ADDENDUM NO. TWO  
NCSB -FBMS

To the Plans and Specifications for:  
Nassau County School Board – Project No. 98110-031  
Fernandina Beach Middle School Kitchen / Dining Remodeling and Campus  
Renovations/Enhancements

Date: October 16, 2018

**FERNANDINA BEACH MIDDLE SCHOOL  
KITCHEN/DINING REMODELING AND CAMPUS  
ADDITIONS AND REMODELING**  
315 Citrona Dr., Fernandina Beach, FL 32034

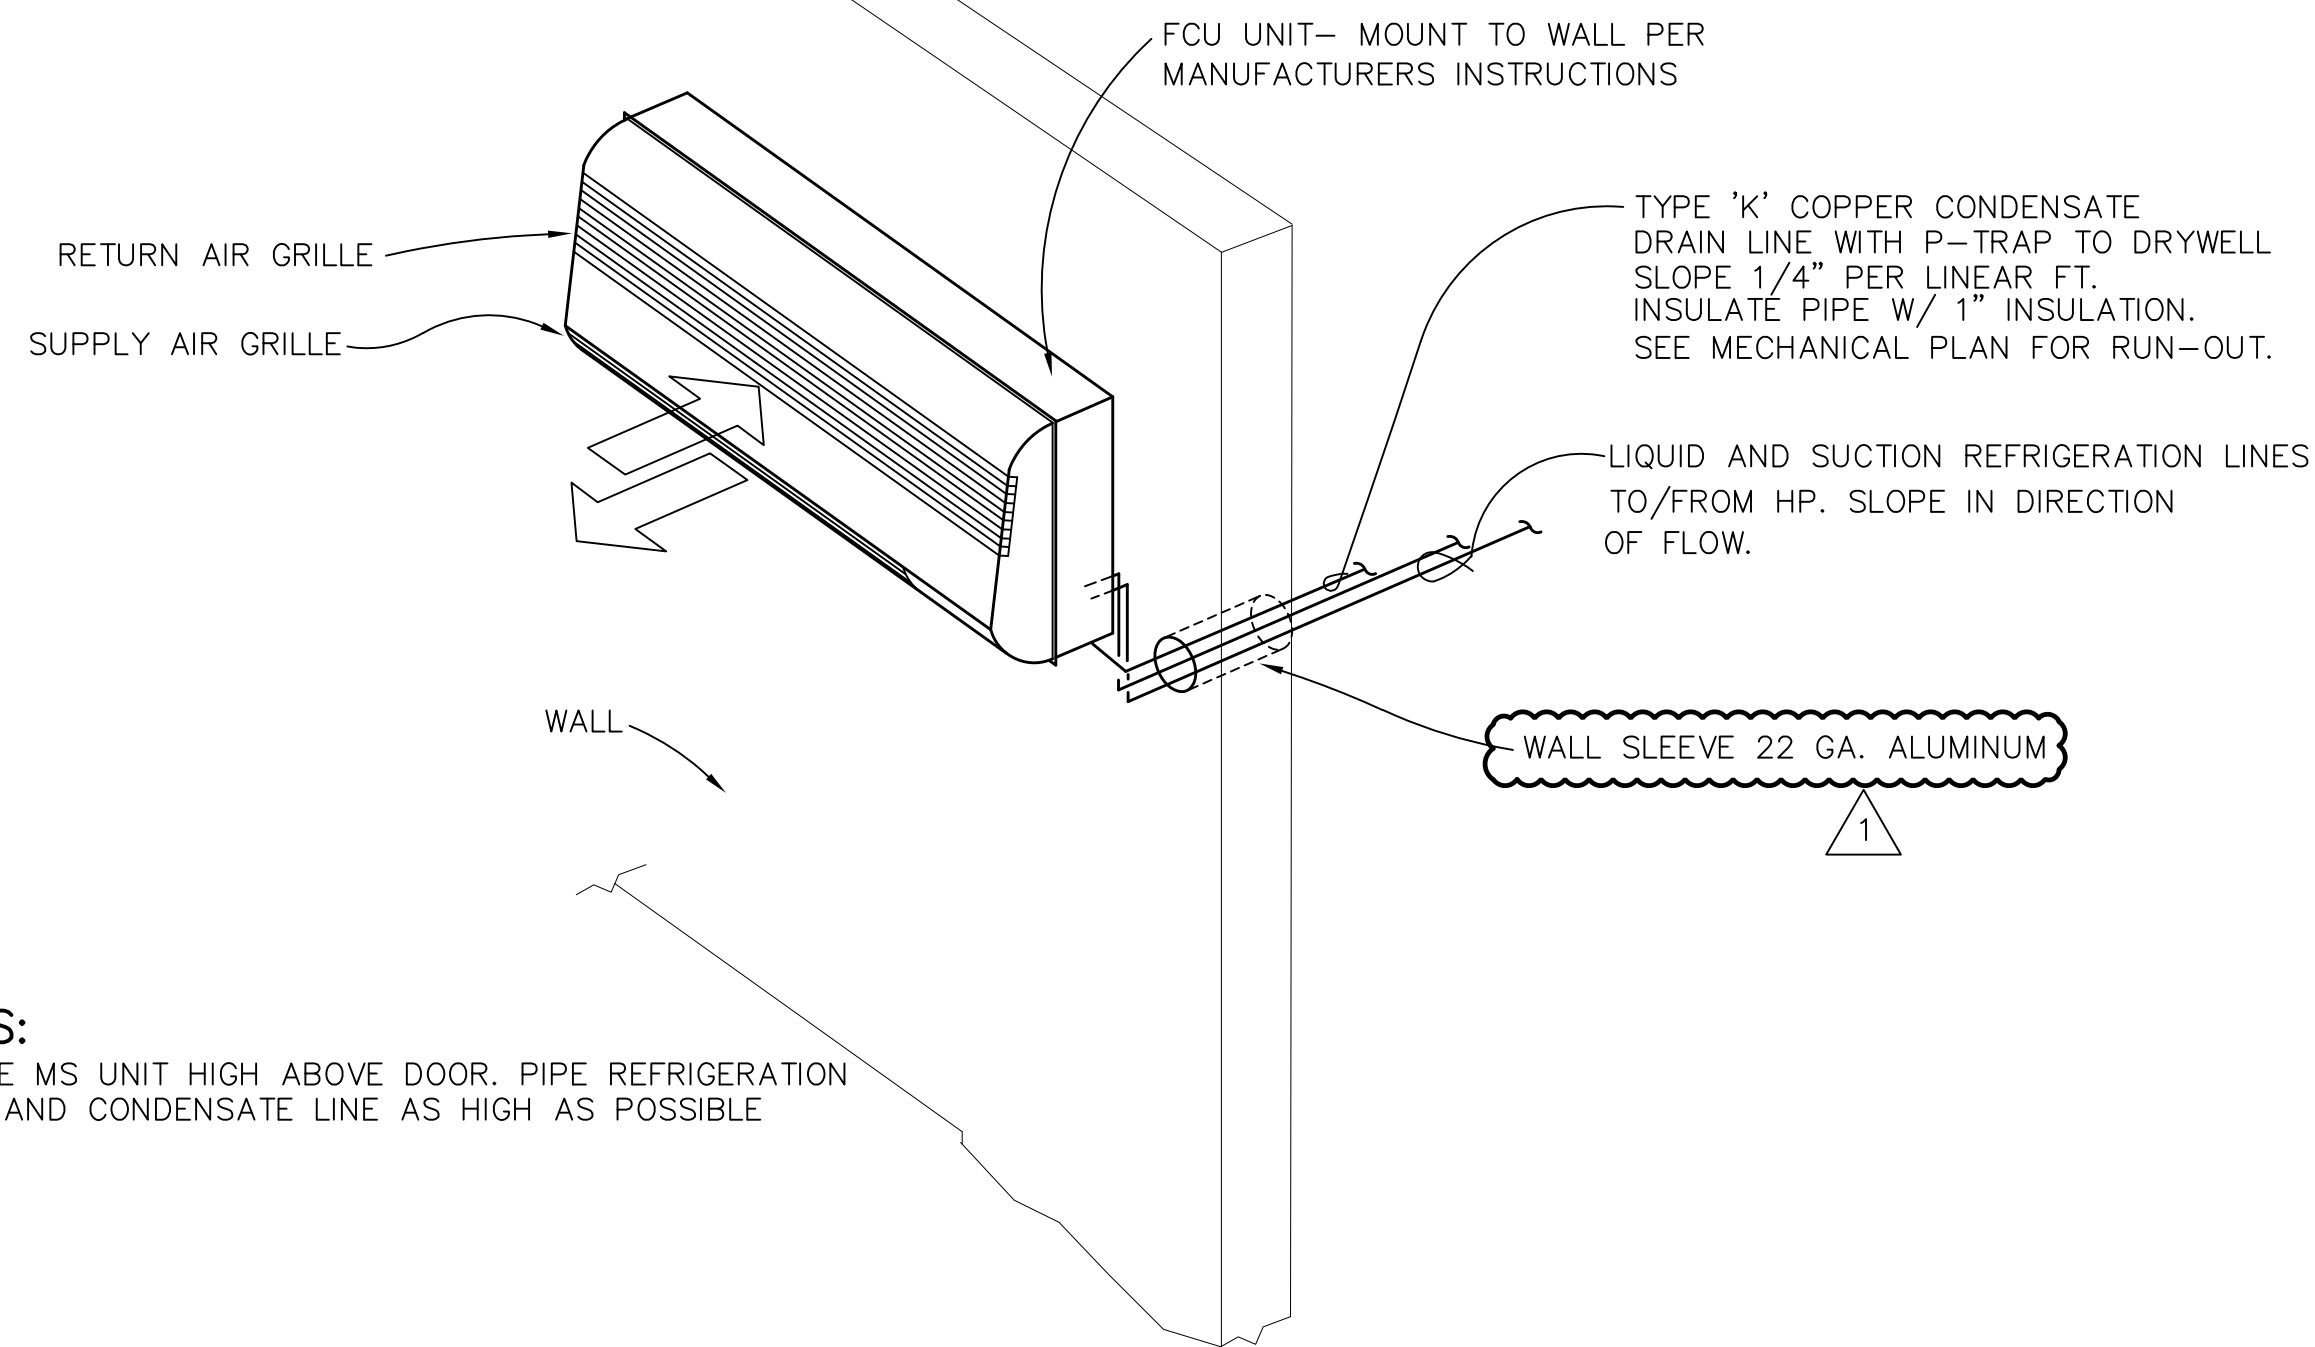
- a. Delete existing Drawing M-7, dated 9/25/2018 and insert Drawing M-7, dated 10/16/2018.
- b. Revise fence note outside of Room 109 new to read “6’ fence with 4’ gate extended 3’0” in front of MS/CU9-1.

**DRYER VENT/LINT TRAP DETAIL** 3  
 NOT TO SCALE M-12

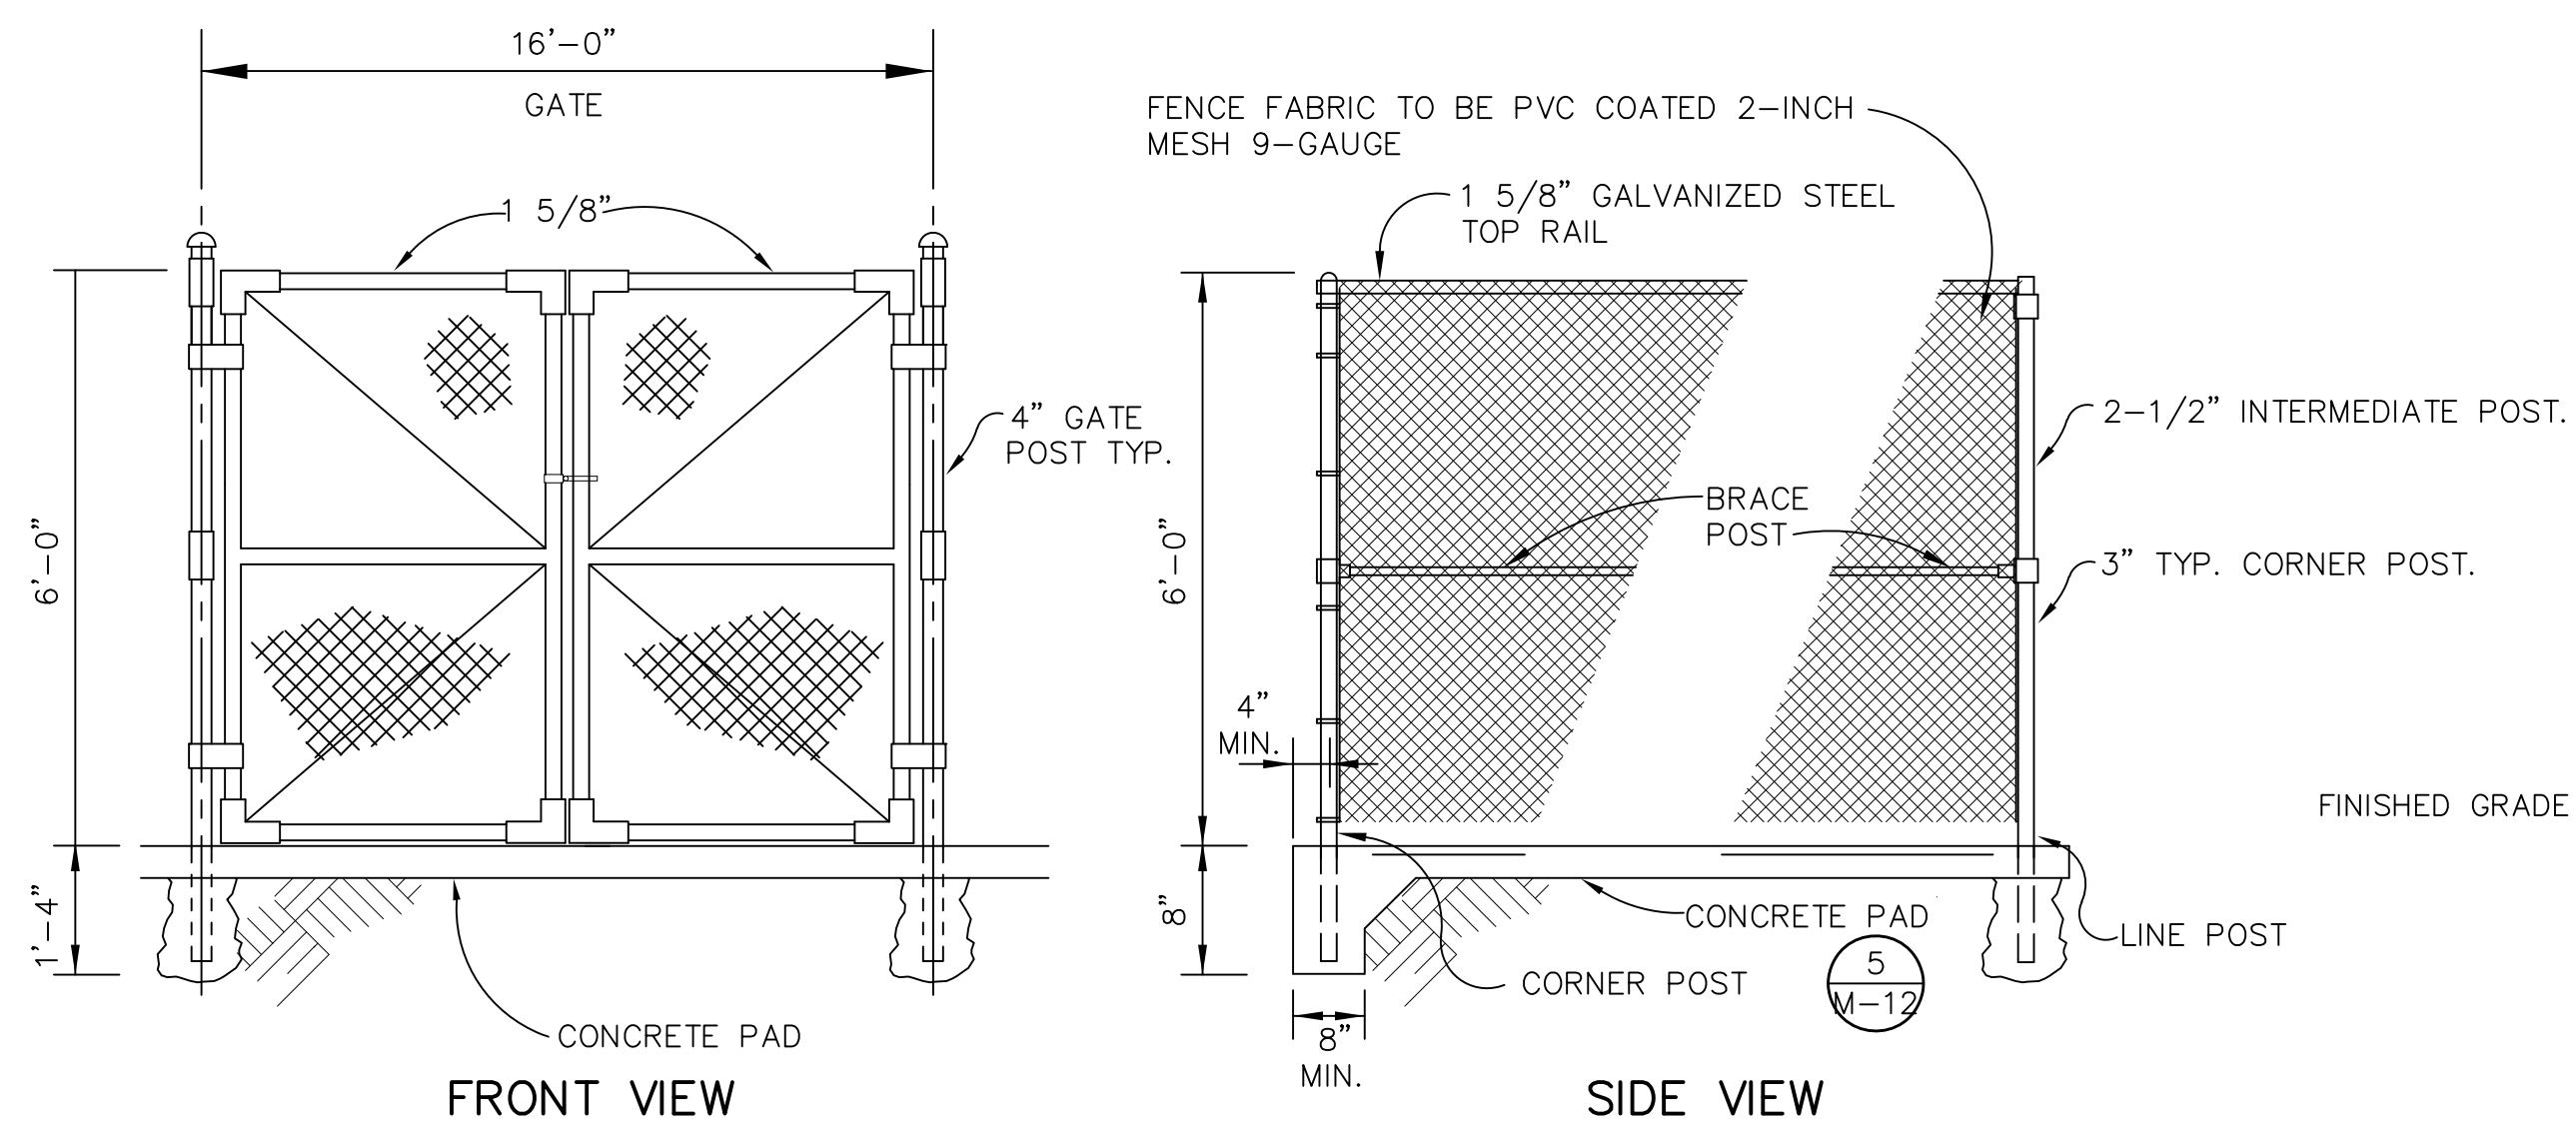
- a. Delete existing Drawing M-12, Dated 9/25/2018 and insert Drawing M-12, dated 10/16/2018.
- b. Revise dryer vent/lint trap detail 3/M-12 to delete CPVC piping to galvanized piping.
